An overview of the main design changes and responses to the feedback given is summarised here:

2.3.2 Pre-Application

Calthorpe Street, Banbury | Design & Access Statement | April 2023

Previously Proposed Site Layout

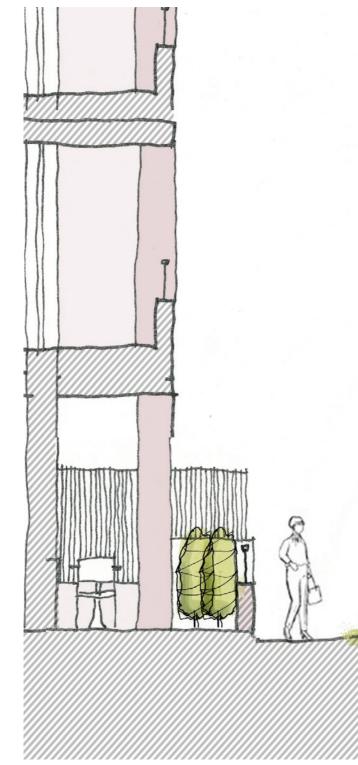
At the stage of the last pre-application meeting, there were concerns that the level of public and private permeability and legibility of the site were insufficient.

Whilst this topic is addressed in detail within the Conservation Officer comments, general concern was expressed with the last pre-application scheme that the overall scale and height of the development was too tall, with the majority being 4/5 storeys, with 6 storeys to Blocks A-D when including the lower ground floor

In response, the overall site layout has been redesigned to achieve the following;

- Much stronger, clearer pedestrian / cycle link through the northern part of the site to the south of Blocks F and G between Calthorpe Street and Marlborough Road. This new route through frames an attractive landscaped view through to the central bay of the library

- Additional pedestrian / cycle link through the site to the south of the modern apartment block on Calthorpe Street and adjacent to our new Gatehouse, which frames a view to the gable ends of the Marlborough Road Methodist Church

The reduction of units discussed earlier (loss of 30 from the previous scheme), is largely due to the reduction in height across the scheme – with the scheme being reduced to largely 3/4 storeys. There are also some 2 storey elements to site edges.

Previously Proposed Car and Cycle Parking - now reconfigured

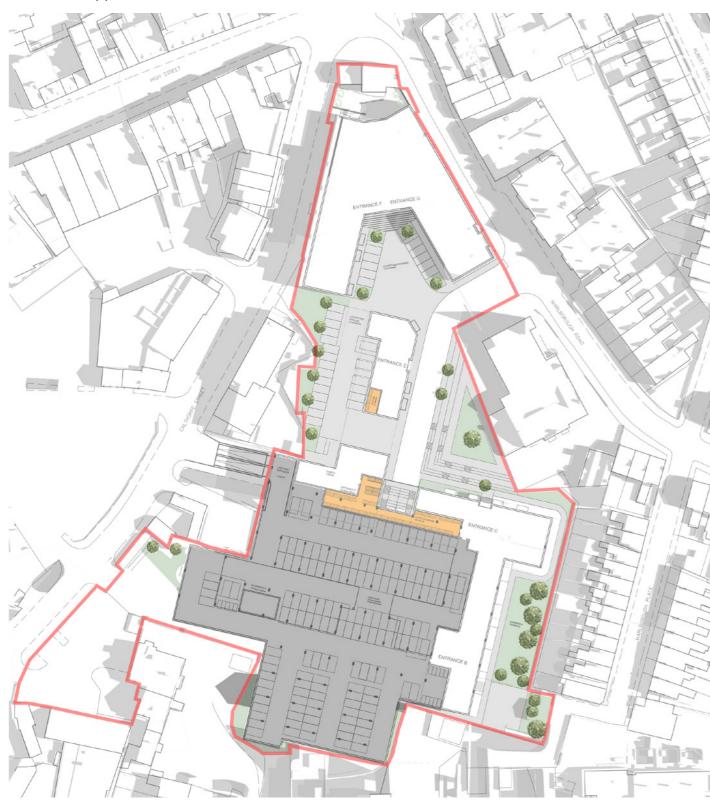
# • Lower ground car park being excessively permeable via multiple cores and has poor sight lines

# • Parking areas for residential and commercial uses should be distinctly separated

#### • Entrance to Block E is not acceptable

Convenient access from the combined parking area to each apartment block core A-D and ease of access out to blocks E - G is required. However, these will be secure cores with access control and as car parking will be allocated, access can be restricted to those residents with spaces or those using the relevant cycle storage.

The car park area has been reduced, and it is now more compact which improves sightlines. It will be well-lit and covered by CCTV. The main vehicle entrance will feature a secure, access controlled gate.

There are no longer any commercial uses within the site and all parking is to be for residential use, other than the retained south west short stay car public park, which is separately accessed and contained.

Block E has been completely redesigned and the rear surface car parking court removed. The entrance to Block E is now from the main area of public realm.
